ADDENDUM No. 2

REQUEST FOR QUOTATIONS No.: 1220-040-2017-038

TITLE: SOUTH SURREY INDOOR POOL
RE-TILING & GUTTER RENOVATION

ADDENDUM ISSUE DATE: March 9, 2017

8 POOL NOSING TRIM DETAIL - REVISION

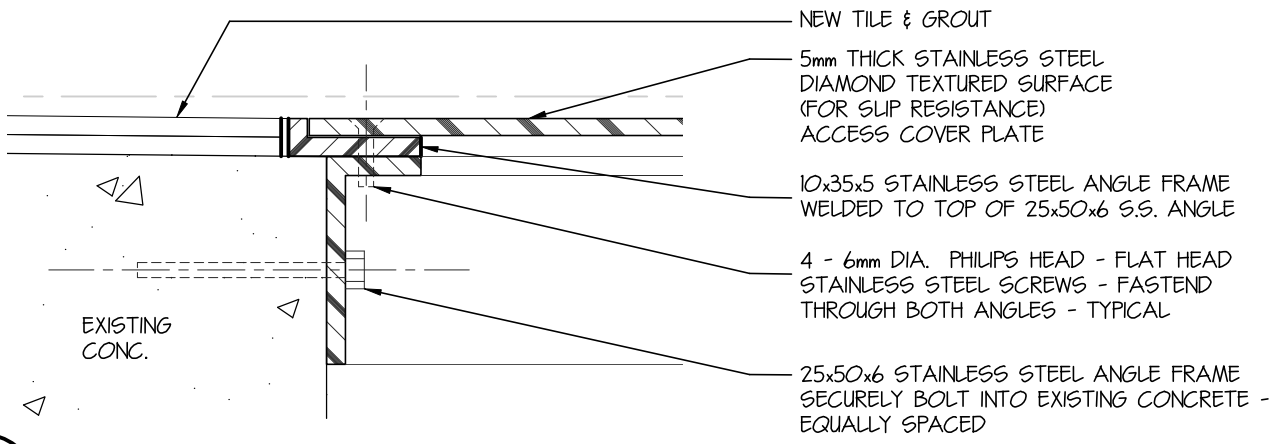
A2. Incorrect no change to FT-4. Refer to SK-01 which redefines and provides proper definition of pool tile edge.

(MAIN POOL TILE DETAIL SHOWN - POOL EDGES FOR WHIRL & TRAINING POOL SIMILAR @ POOL DECK TO POOL NOSING)

1 **ENLARGED PLAN (NEW ACCESS HATCH IN POOL DECK)**
 A-03 1:20 REF. DWG. A-01

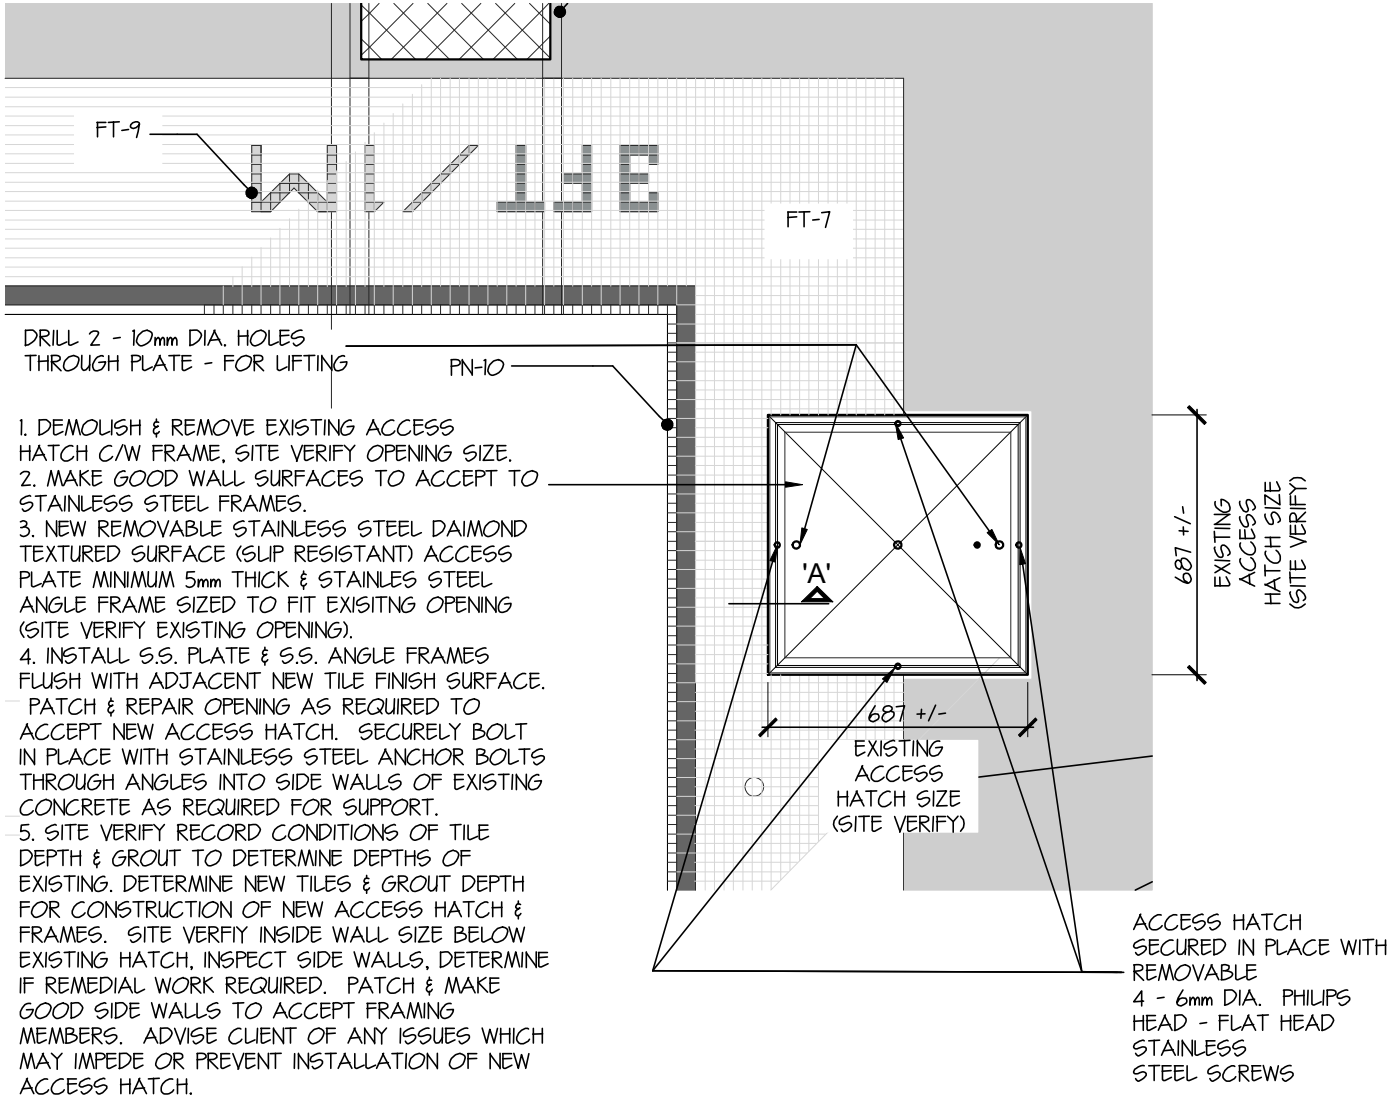
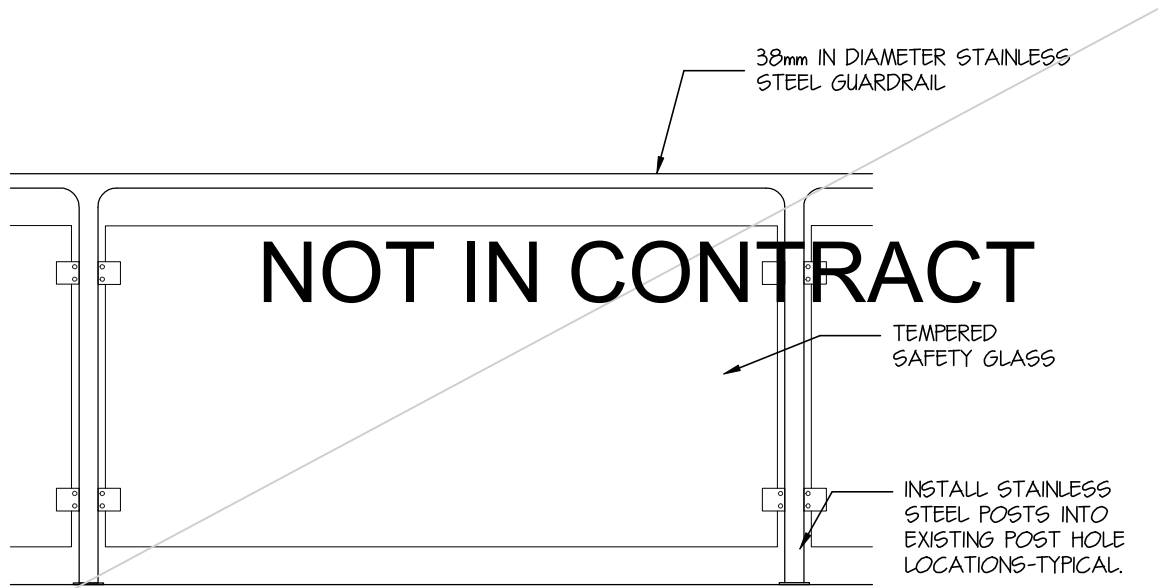
- DRILL 2 - 10mm DIA. HOLES THROUGH PLATE - FOR LIFTING
1. DEMOLISH & REMOVE EXISTING ACCESS HATCH C/W FRAME, SITE VERIFY OPENING SIZE.
 2. MAKE GOOD WALL SURFACES TO ACCEPT TO STAINLESS STEEL FRAMES.

3. NEW REMOVABLE STAINLESS STEEL DAIMOND TEXTURED SURFACE (SLIP RESISTANT) ACCESS PLATE MINIMUM 5mm THICK & STAINLES STEEL ANGLE FRAME SIZED TO FIT EXISITNG OPENING (SITE VERIFY EXISTING OPENING).

4. INSTALL S.S. PLATE & S.S. ANGLE FRAMES FLUSH WITH ADJACENT NEW TILE FINISH SURFACE. PATCH & REPAIR OPENING AS REQUIRED TO ACCEPT NEW ACCESS HATCH. SECURELY BOLT IN PLACE WITH STAINLESS STEEL ANCHOR BOLTS THROUGH ANGLES INTO SIDE WALLS OF EXISTING CONCRETE AS REQUIRED FOR SUPPORT.

5. SITE VERIFY RECORD CONDITIONS OF TILE DEPTH & GROUT TO DETERMINE DEPTHS OF EXISTING. DETERMINE NEW TILES & GROUT DEPTH FOR CONSTRUCTION OF NEW ACCESS HATCH & FRAMES. SITE VERIFY INSIDE WALL SIZE BELOW EXISTING HATCH, INSPECT SIDE WALLS, DETERMINE IF REMEDIAL WORK REQUIRED. PATCH & MAKE GOOD SIDE WALLS TO ACCEPT FRAMING MEMBERS. ADVISE CLIENT OF ANY ISSUES WHICH MAY IMPEDE OR PREVENT INSTALLATION OF NEW ACCESS HATCH.

10
A-05
GLASS GUARD RAILS - ELEVATION
 1 : 20 REF. DWG. A-01
 (TYPICAL SECTION OF GUARDRAIL TO BE CONSTRUCTED)

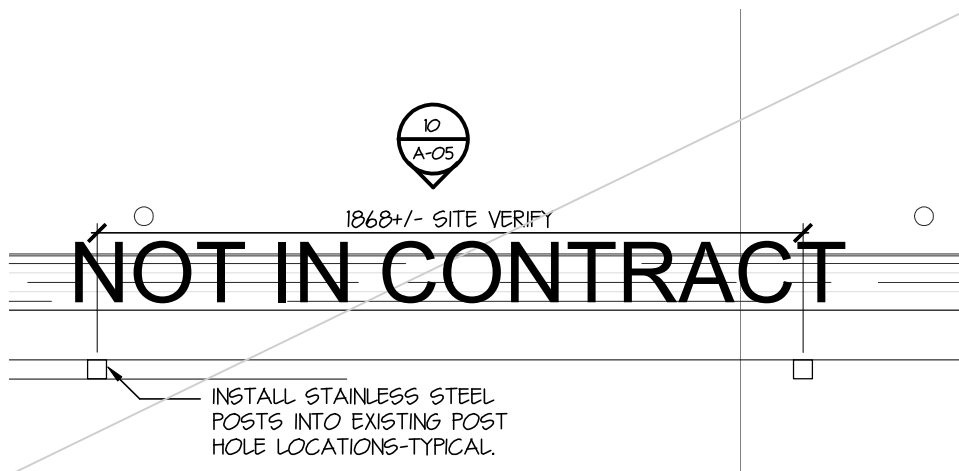
CHERNOFF THOMPSON ARCHITECTS Vancouver, B.C. Telephone: 604.669.9460	DRAWING:	SCALE: AS SHOWN	REV: 0	
		DELETED DETAILS - NOT IN CONTRACT	DATE: 03/03/2017	
	PROJECT:	SOUTH SURREY POOL - RE-TILING & GUTTER RENO	DRAWN: PST	SK-03
			PROJECT NO: 36046

1 FLOOR PLAN - PARTIAL
 A-01 1:100

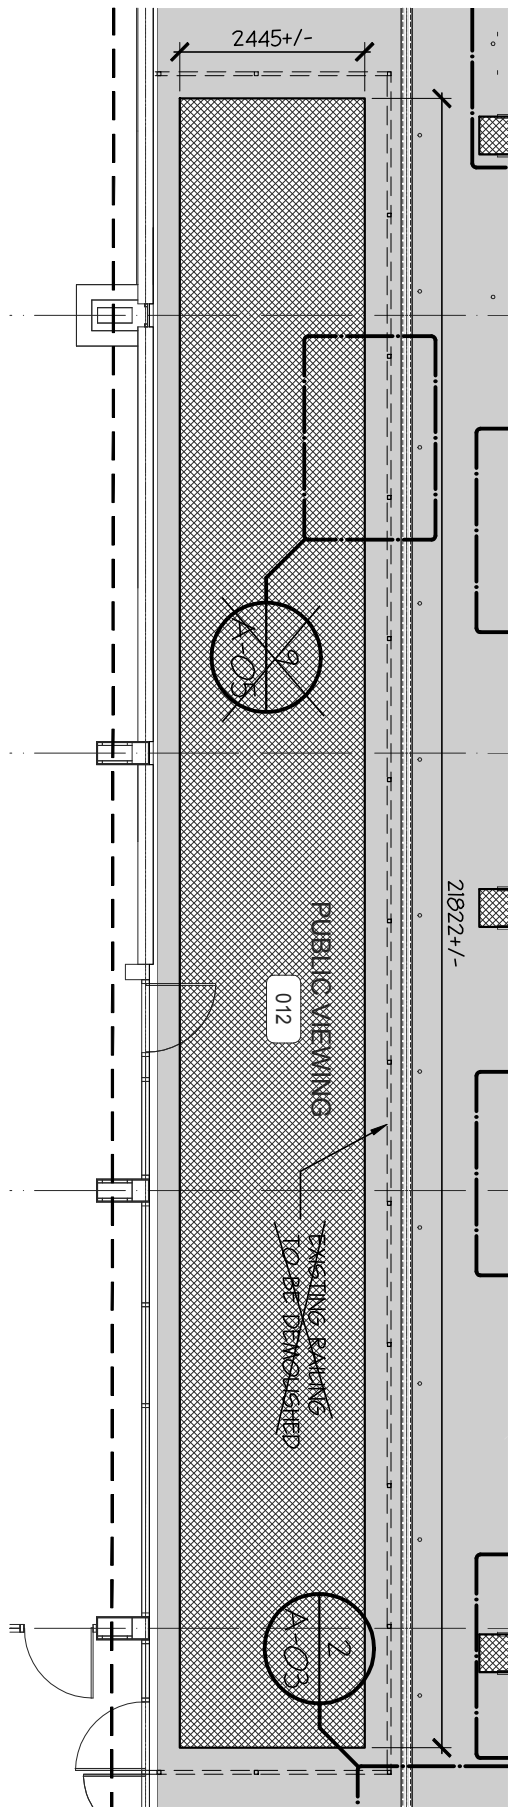
DEMOLITION & REMOVAL & INSTALLATION OF NEW
 GUARDRAIL NOT IN CONTRACT. LEAVE EXISTING AS IS,
 WORK NEW TILING AROUND - TYPICAL

2 EXISTING TRENCH/GUTTER DRAIN DETAIL
A-05 15 REF. DWG. A-05

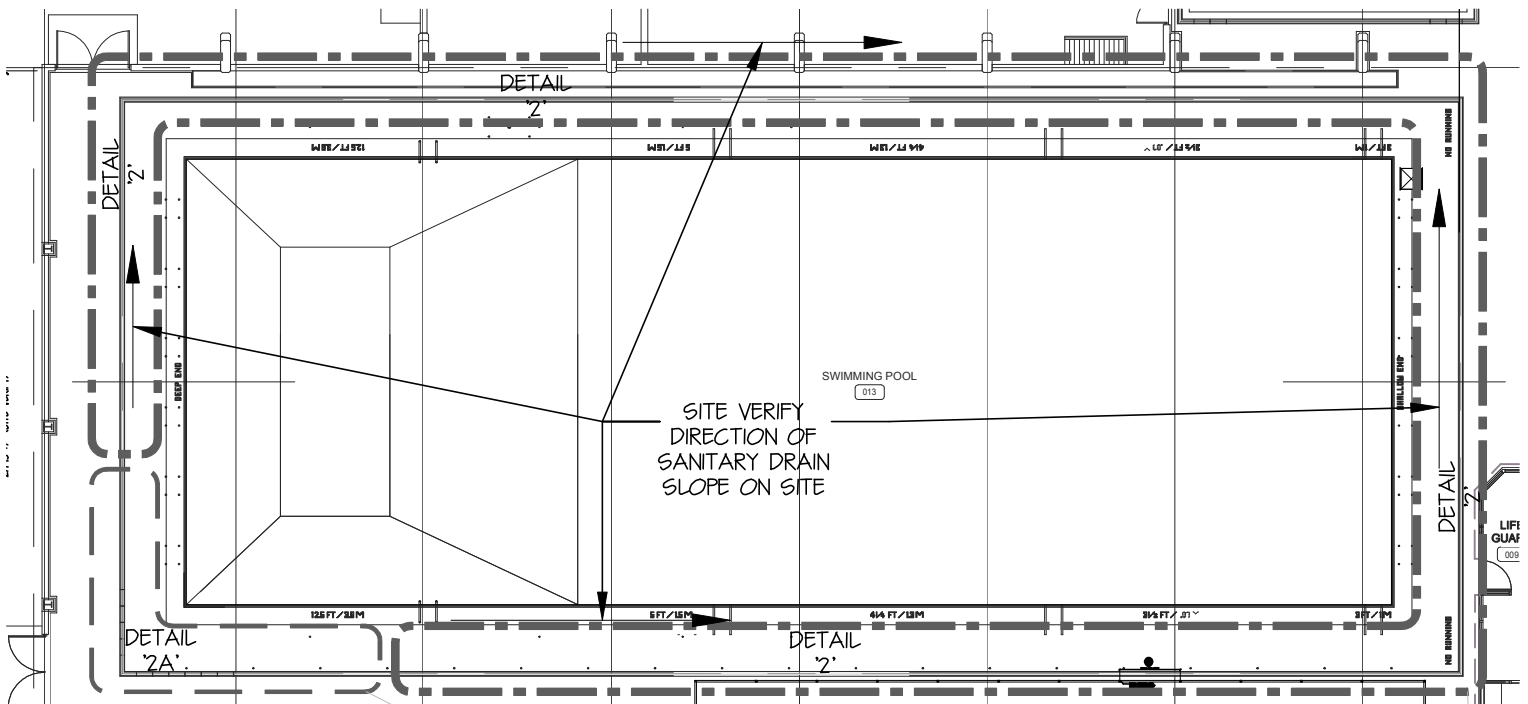
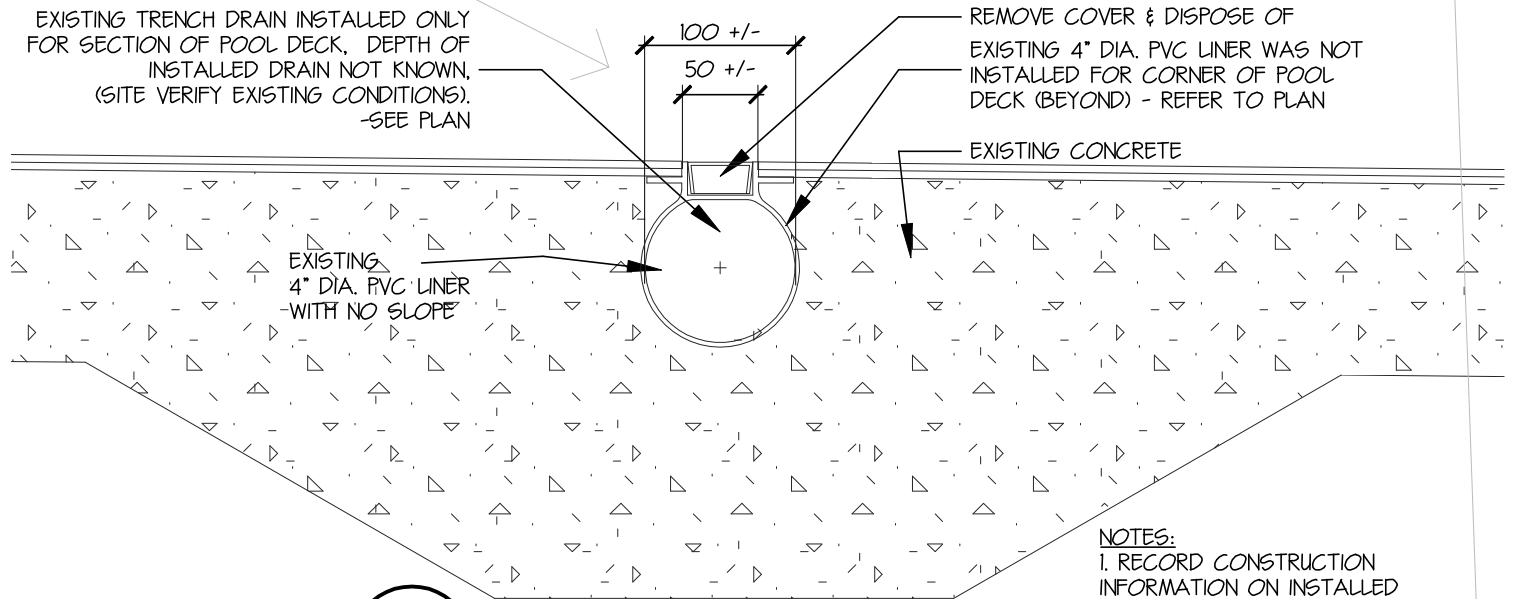
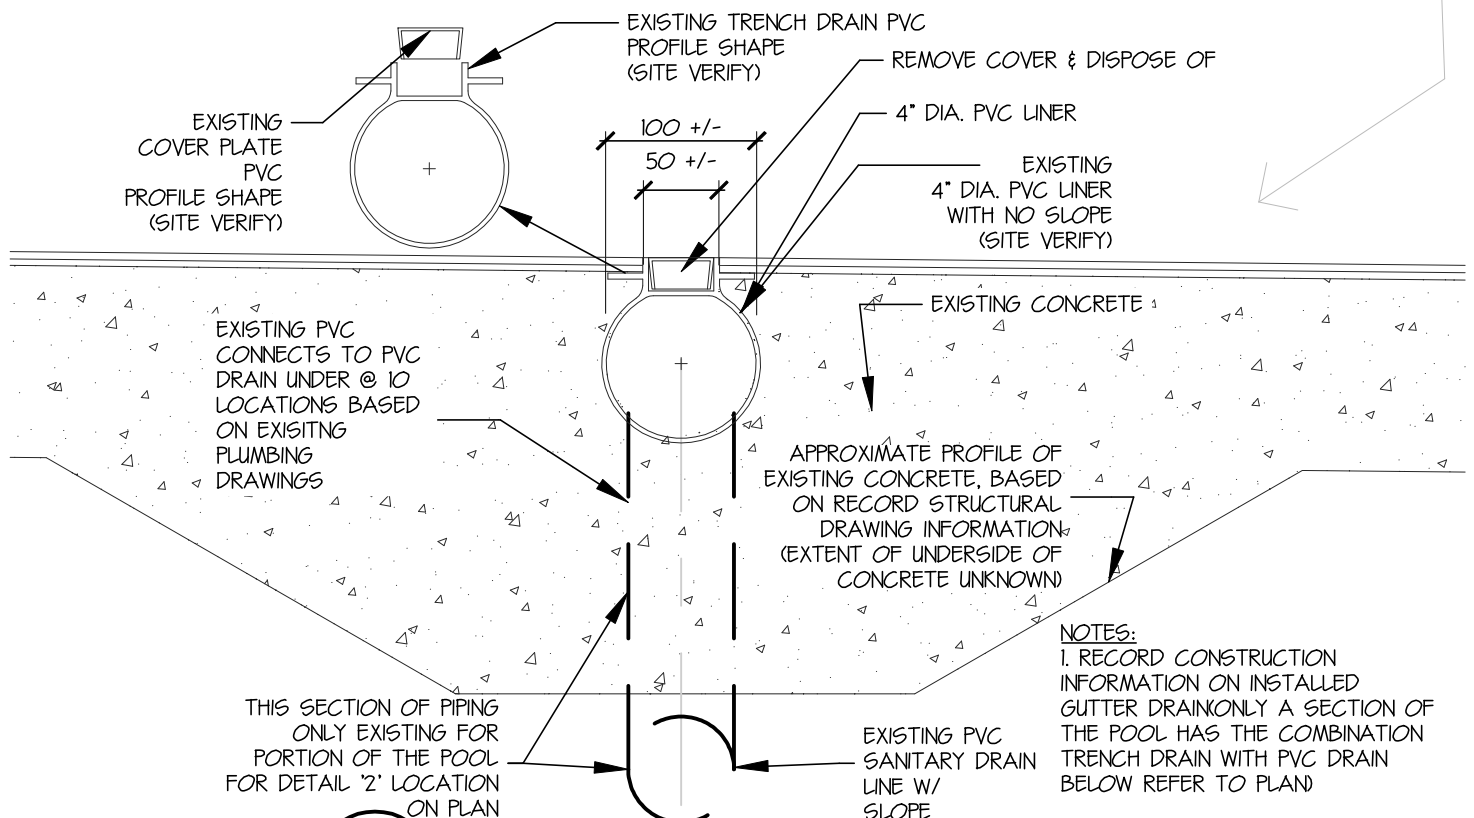
PARTIAL PLAN OF POOL - SHOWING EXISTING POOL DRAIN TYPES FOR REFERENCE ONLY - SITE VERIFY EXTENT OF TYPES

EXISTING TRENCH DRAIN INSTALLED ONLY FOR SECTION OF POOL DECK, DEPTH OF INSTALLED DRAIN NOT KNOWN, (SITE VERIFY EXISTING CONDITIONS). -SEE PLAN

NOTES:
1. RECORD CONSTRUCTION INFORMATION ON INSTALLED GUTTER DRAIN (SITE VERIFY)

NOTES:
1. RECORD CONSTRUCTION INFORMATION ON INSTALLED GUTTER DRAIN ONLY A SECTION OF THE POOL HAS THE COMBINATION TRENCH DRAIN WITH PVC DRAIN TRENCH DRAIN WITH PVC DRAIN BELOW REFER TO PLAN

CHERNOFF THOMPSON ARCHITECTS Vancouver, B.C. Telephone: 604.669.9460	DRAWING:	SCALE:	REV:
	REVISED DETAIL #4 & 5 SHT. A-05	AS SHOWN	0
	PROJECT:	DATE:	SK-06
	SOUTH SURREY POOL - RE-TILING & GUTTER RENO	06/03/2017	
	DRAWN:		
	PST		
	PROJECT NO:		
	36046

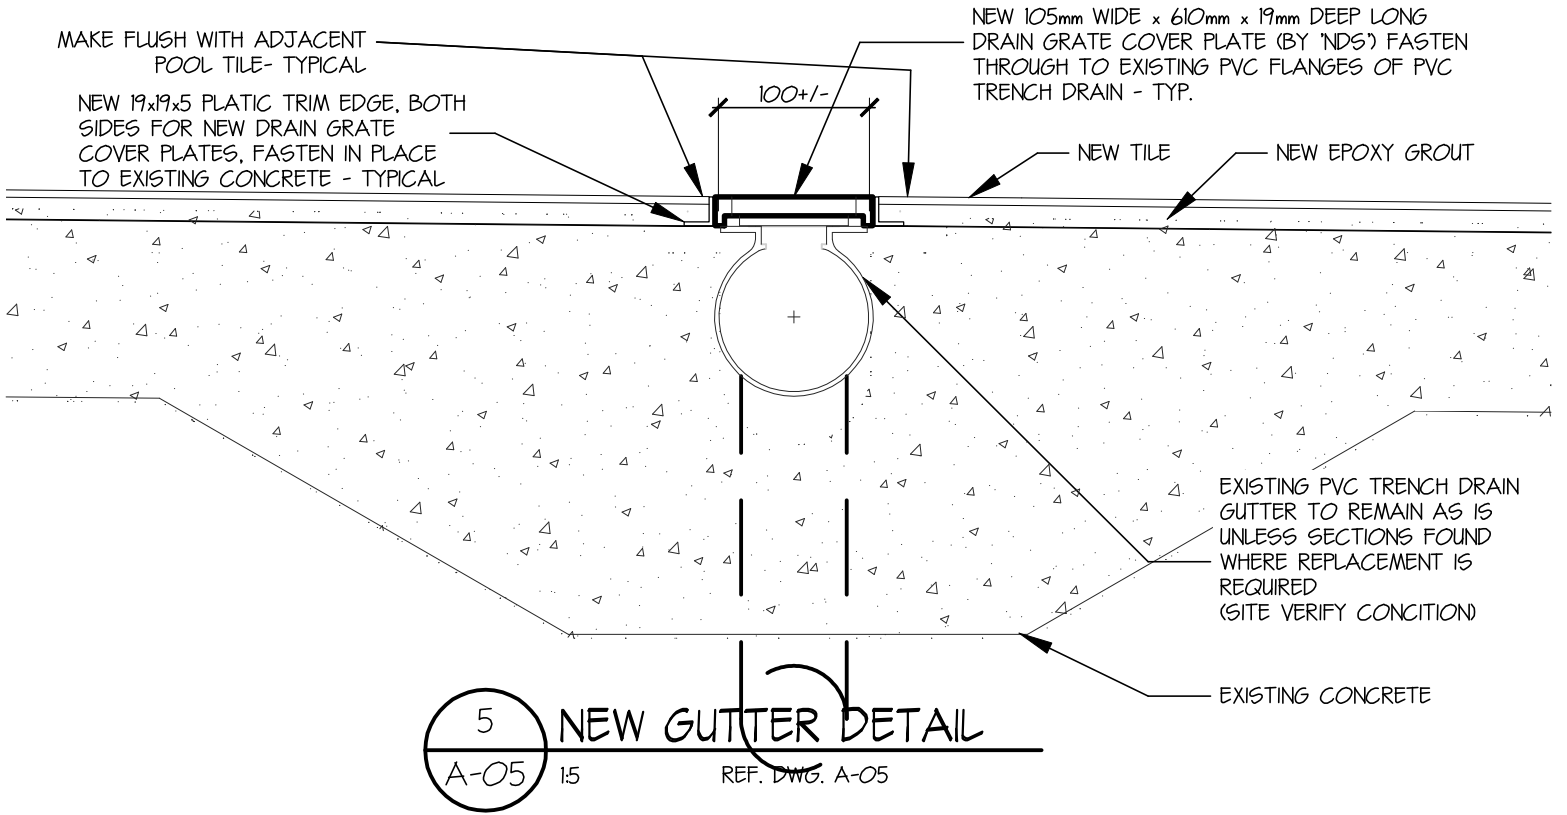
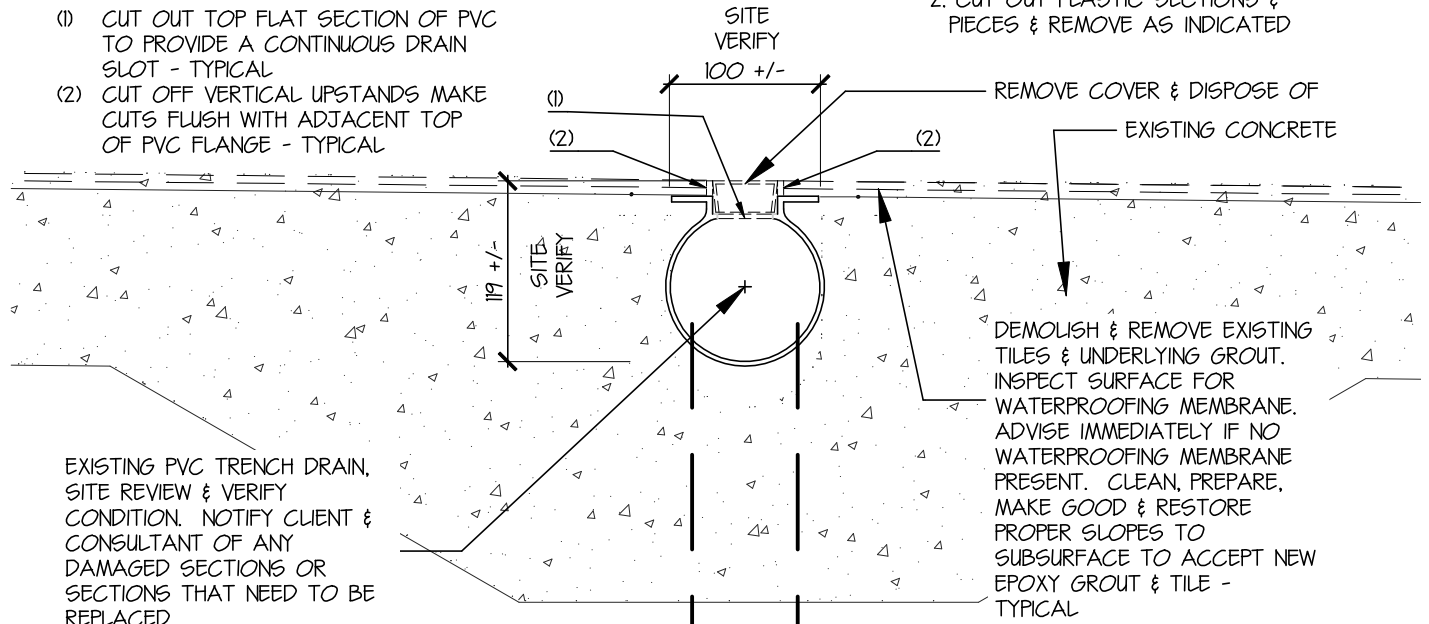
ELEMENTS OF EXISTING TRENCH DRAIN GUTTER TO BE CUT & REMOVED:

- (1) CUT OUT TOP FLAT SECTION OF PVC TO PROVIDE A CONTINUOUS DRAIN SLOT - TYPICAL
- (2) CUT OFF VERTICAL UPSTANDS MAKE CUTS FLUSH WITH ADJACENT TOP OF PVC FLANGE - TYPICAL

- 1. EXISTING TRENCH DRAIN TO REMAIN.
- 2. CUT OUT PLASTIC SECTIONS & PIECES & REMOVE AS INDICATED
